# Printed Circuit Board Design Updates

Andrew Landrie and Xu Zhai  
UW Physical Sciences Laboratory  
March 27, 2019

# Design Updates – Overview

# X-Layer Foot Boards

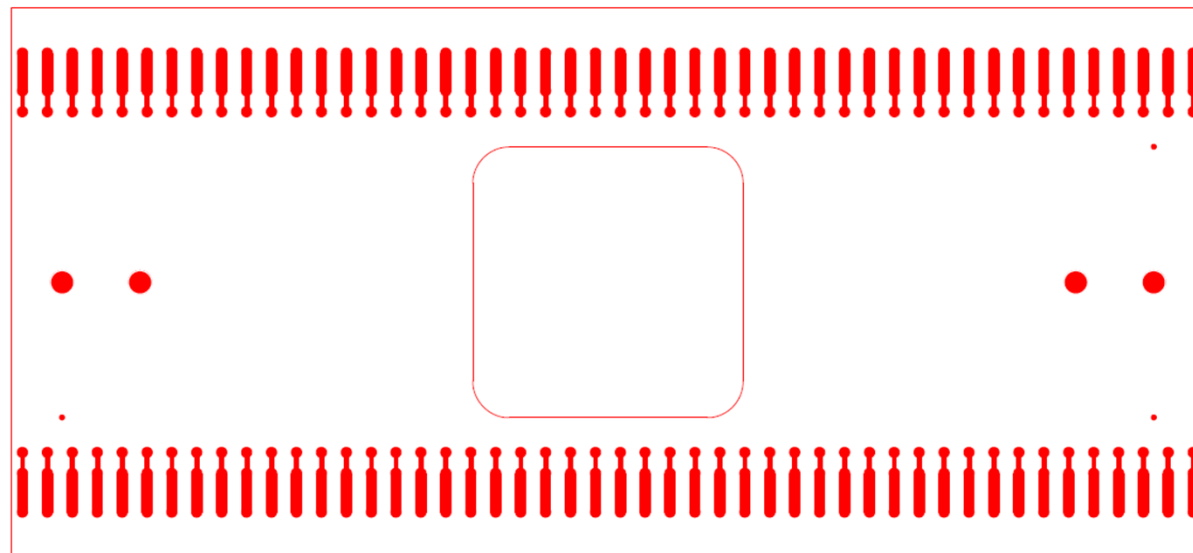
- Foot Boards and Side Boards
  - Dimensions stretched to fit larger frame tubes
  - Multi-layer boards are required in some locations
- Head Boards
  - Increased spacing between wire traces
  - Improved interface for electrical testing
- Hardware Improvements
  - Custom Mill-Max sockets and pins
  - Stronger threaded inserts in boards

# X-layer Head Board: ProtoDUNE

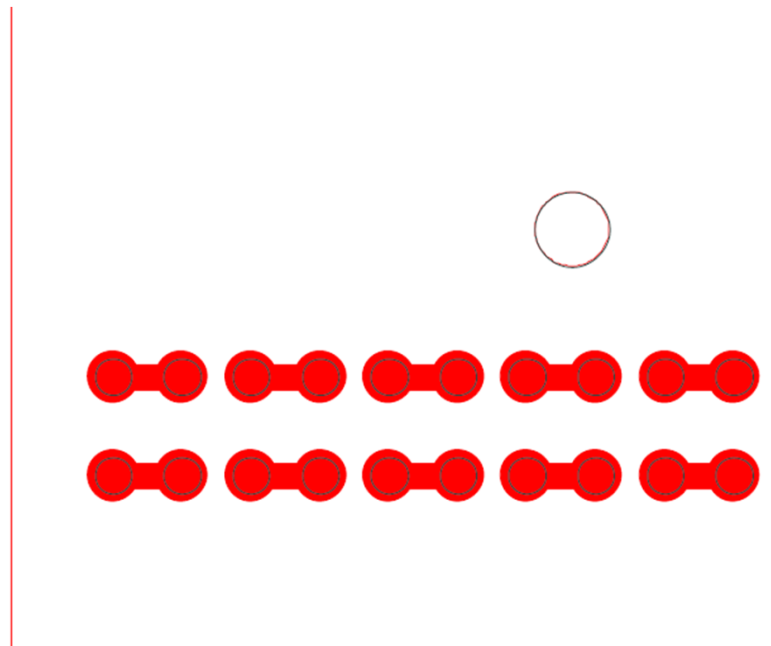
- Spacing of 0.5 mm between channels limits the safe voltage that can be applied between adjacent wires (~100 V)
- Increased spacing is desired to support voltage differences as high as 400 V

# X-layer Head Board: DUNE

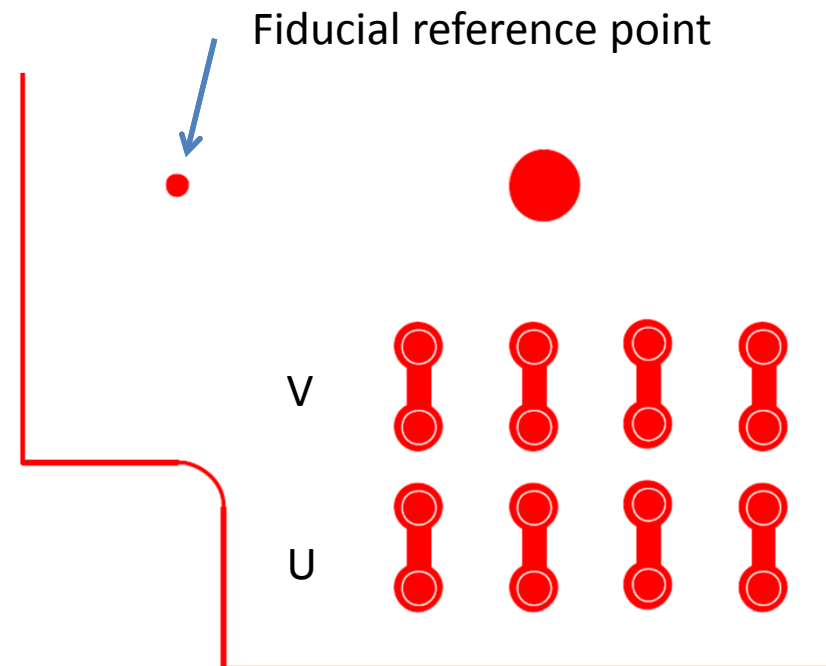
- Spacing between U and V wire channels has increased to 2.5 mm
- Board edge was moved 4.0 mm to accommodate increased channel spacing
- Fiducials were added to all boards to support inspection by automatic vision systems

# X-layer Head Board: DUNE

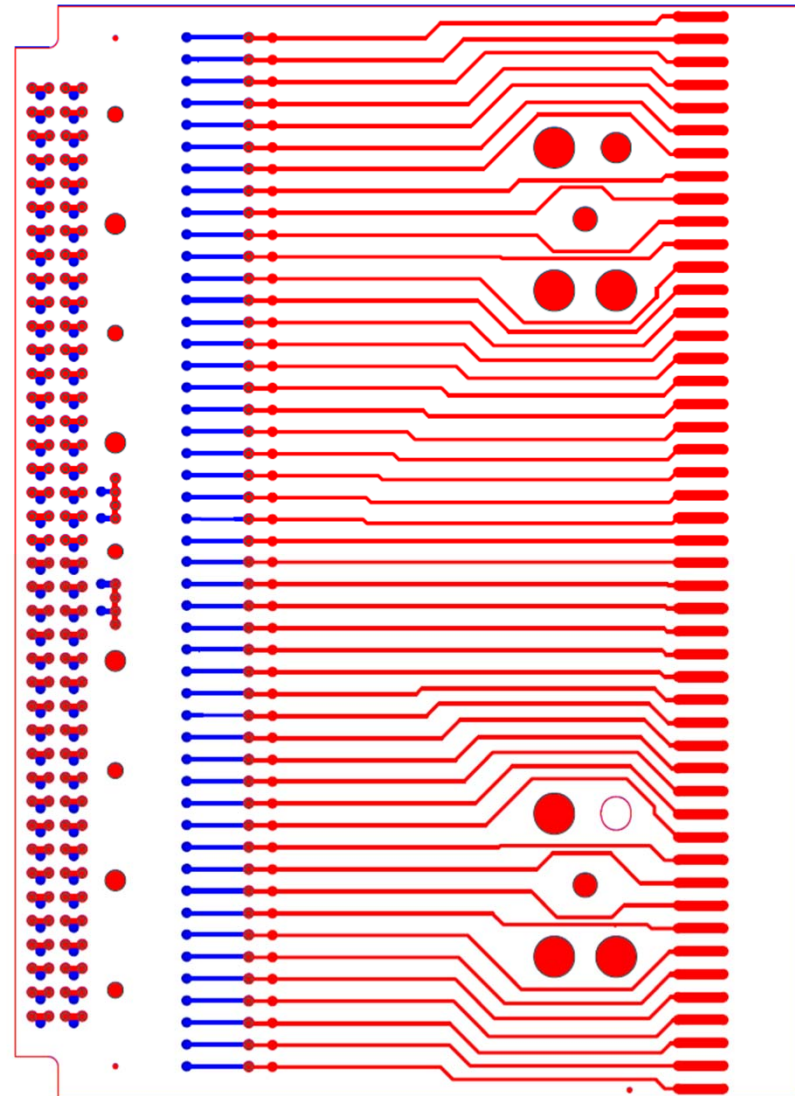
- Landing pads were added to the bottom side of X head boards (blue traces)
- Pads allow the attachment of test headers in place of CR boards
- Headers use spring-loaded contact pins

# Test Header Concept

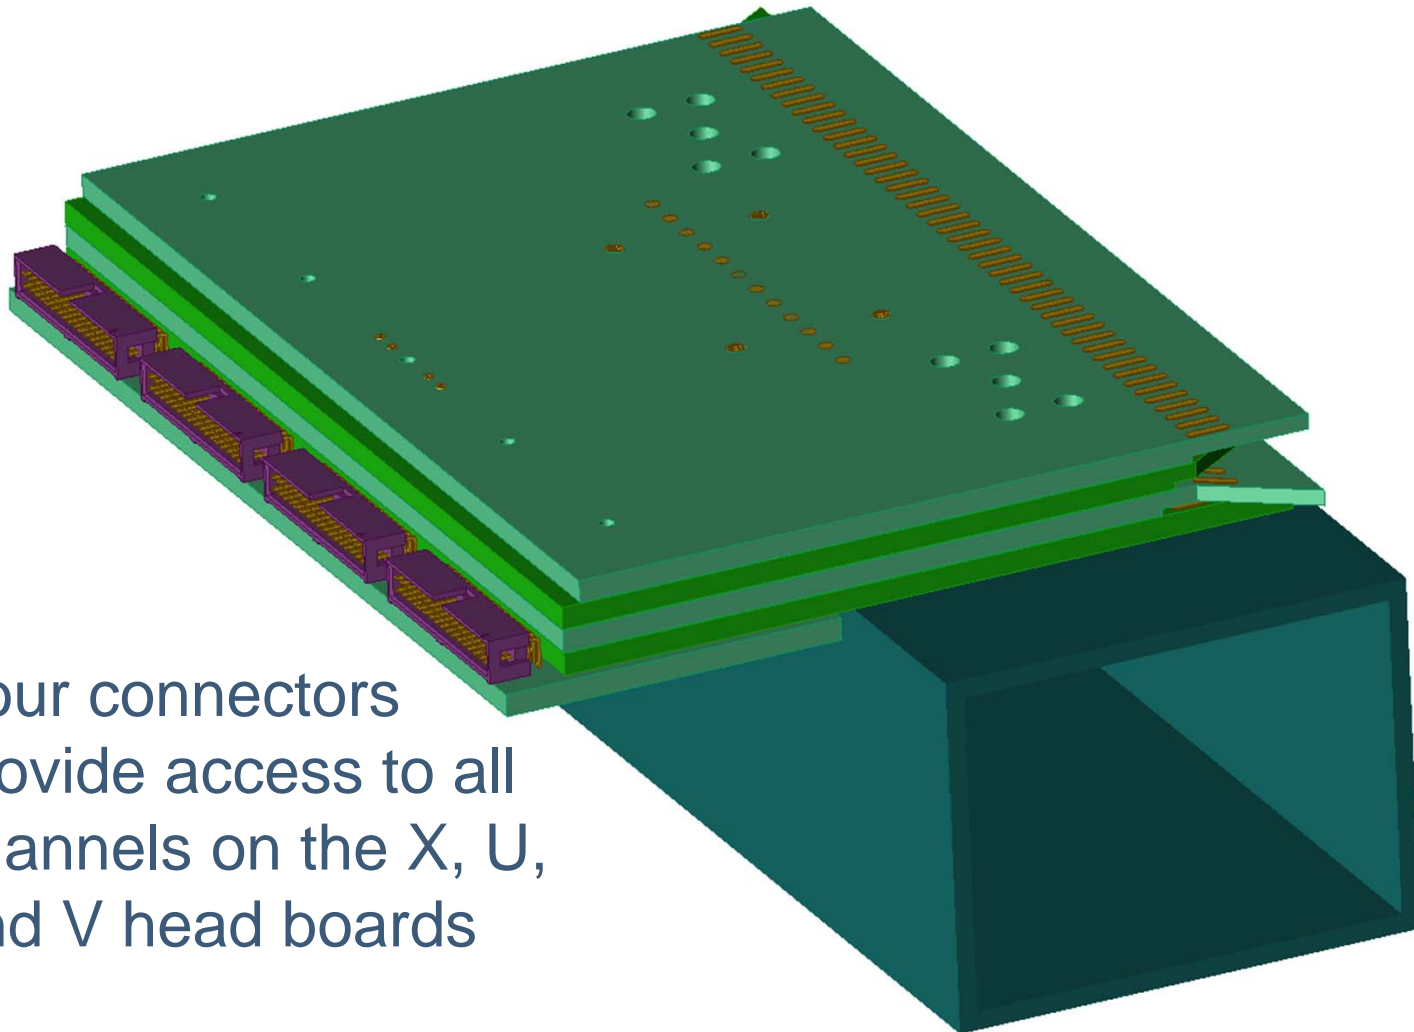
- Four connectors provide access to all channels on the X, U, and V head boards

# New CR Board

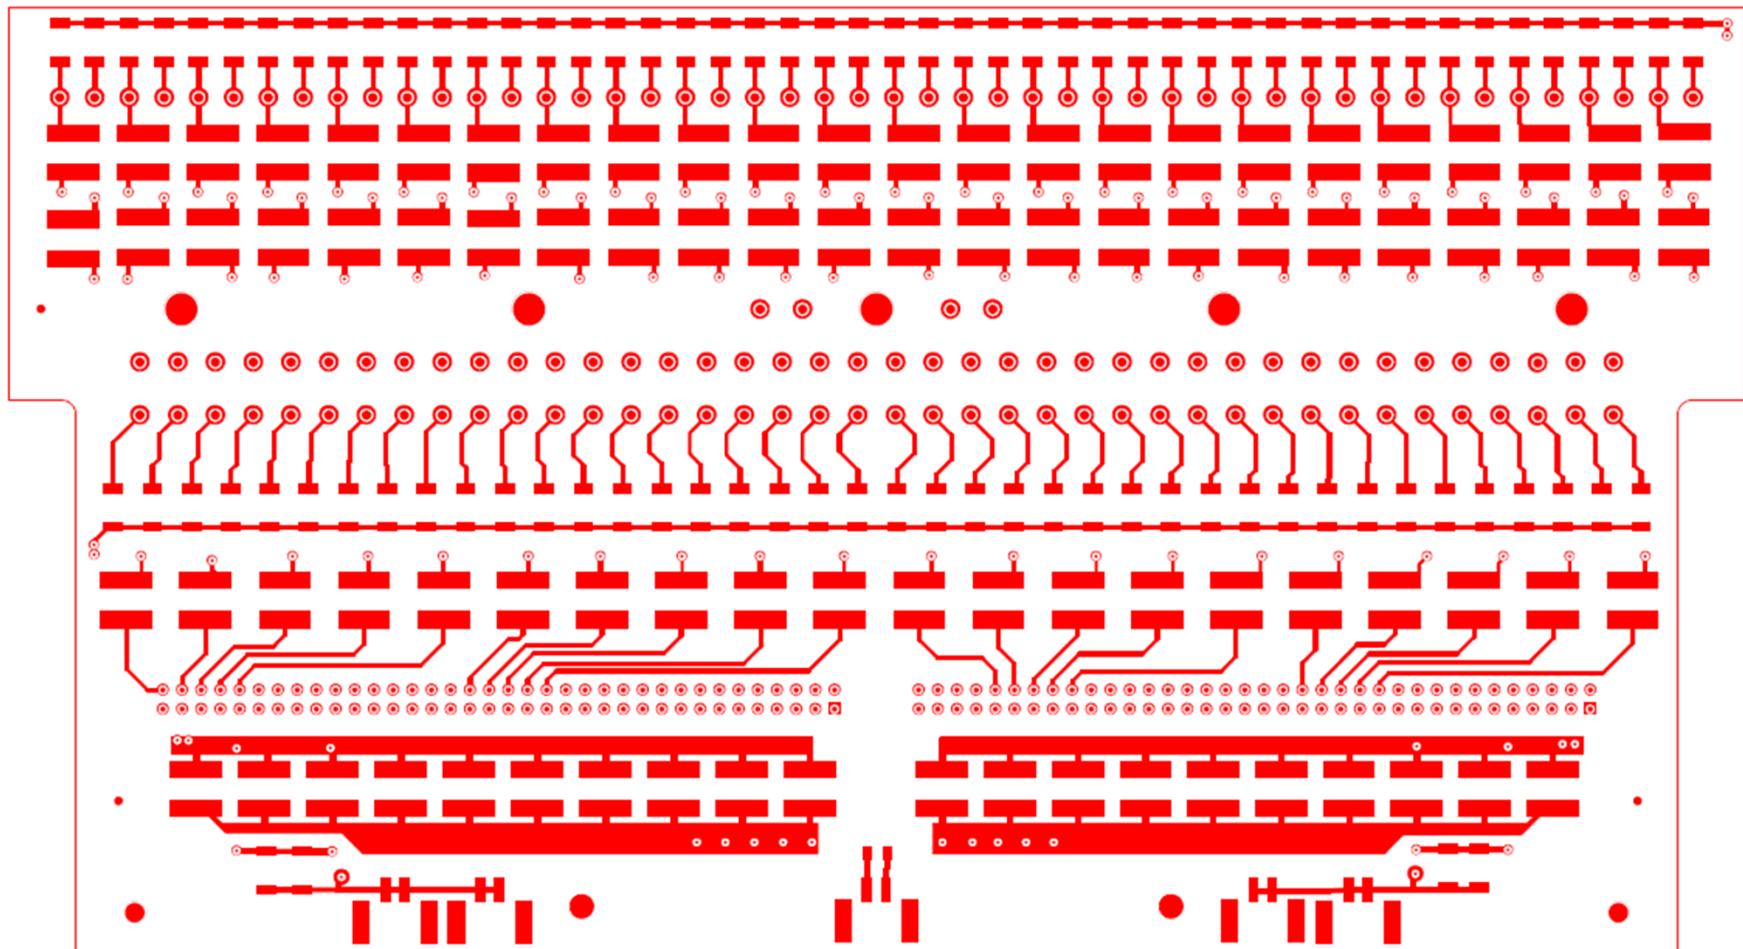
Minor changes only

# ProtoDUNE Sockets and Pins

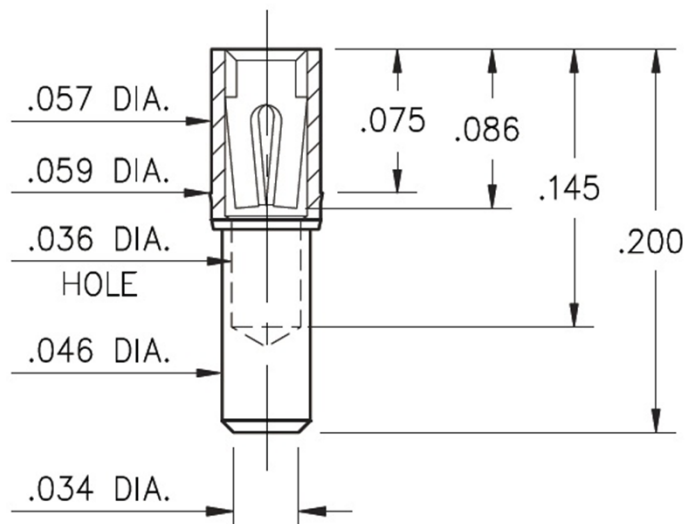
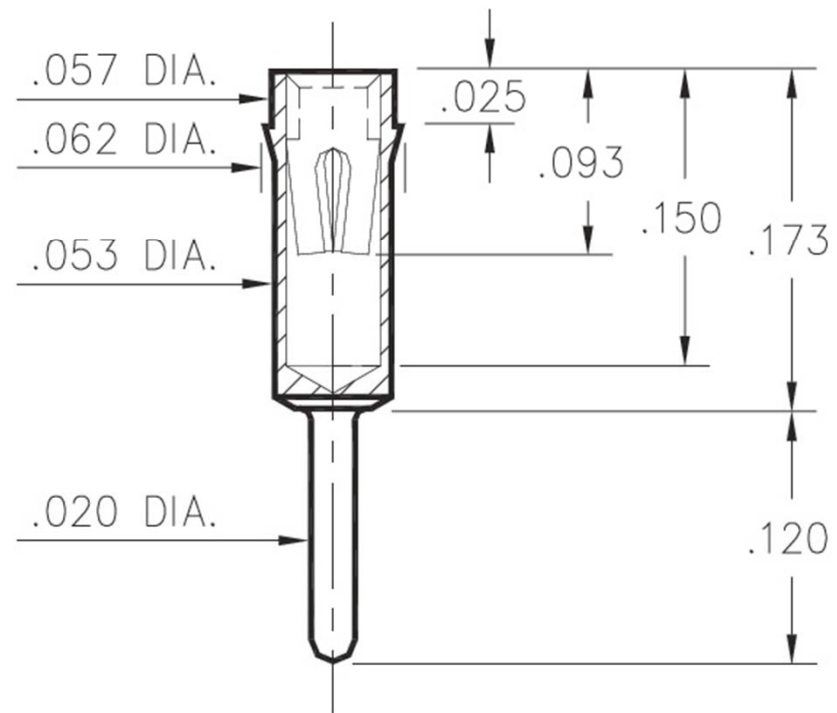
Standard catalog items had some performance issues

# CE Assembly Installation

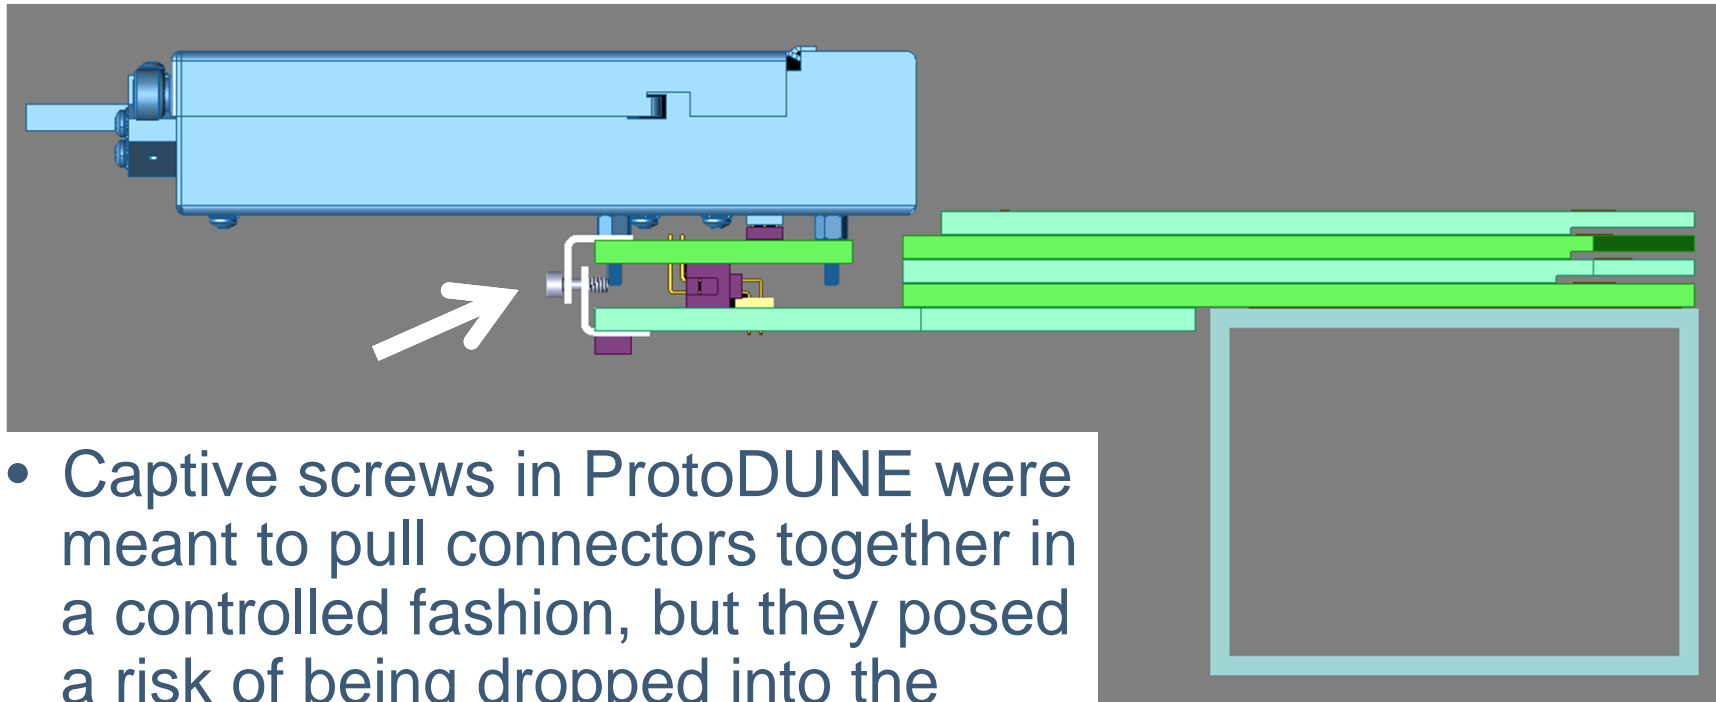
- Captive screws in ProtoDUNE were meant to pull connectors together in a controlled fashion, but they posed a risk of being dropped into the cryostat during CE installation or removal

# CE Assembly Installation

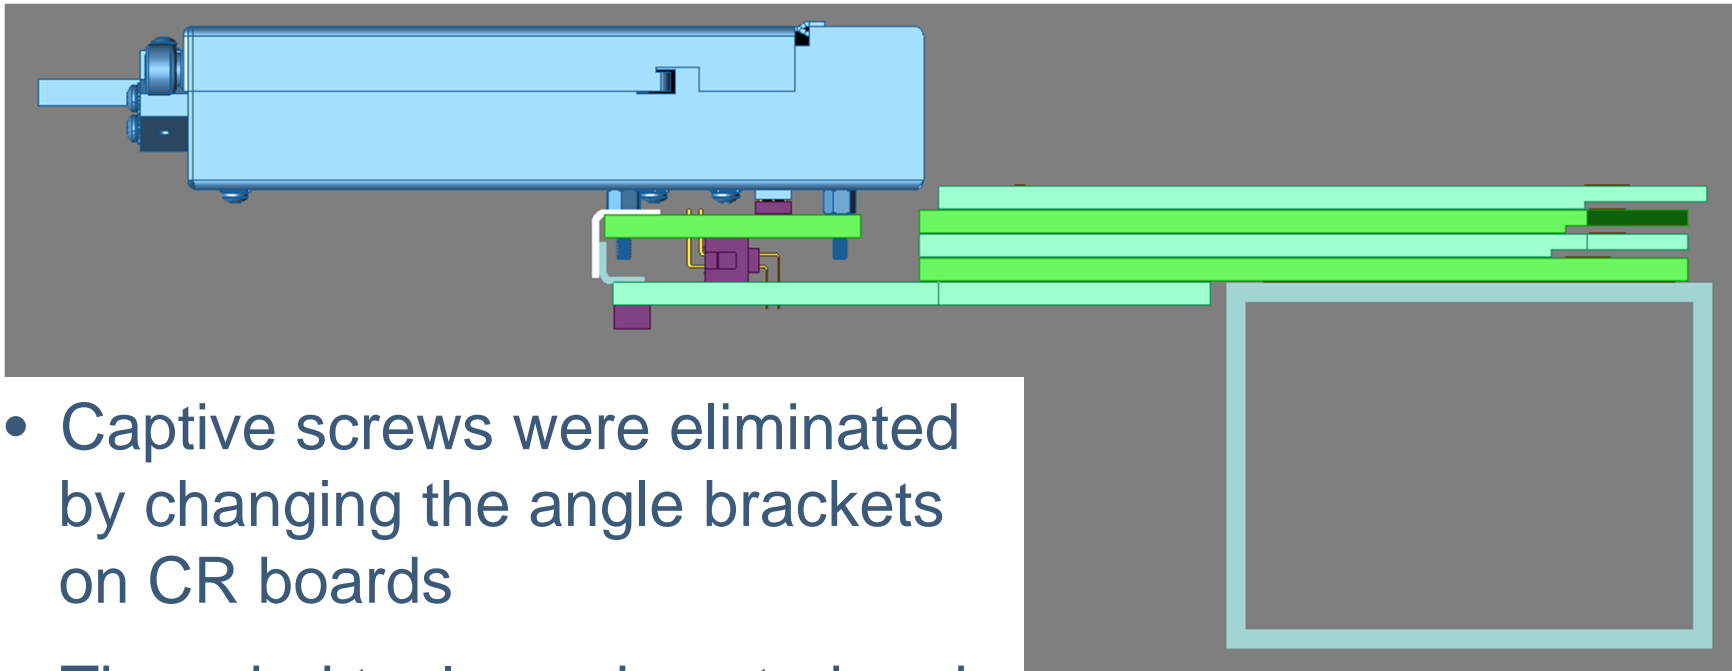
- Captive screws were eliminated by changing the angle brackets on CR boards
- Threaded tools are inserted and rotated to pull connectors together, then removed
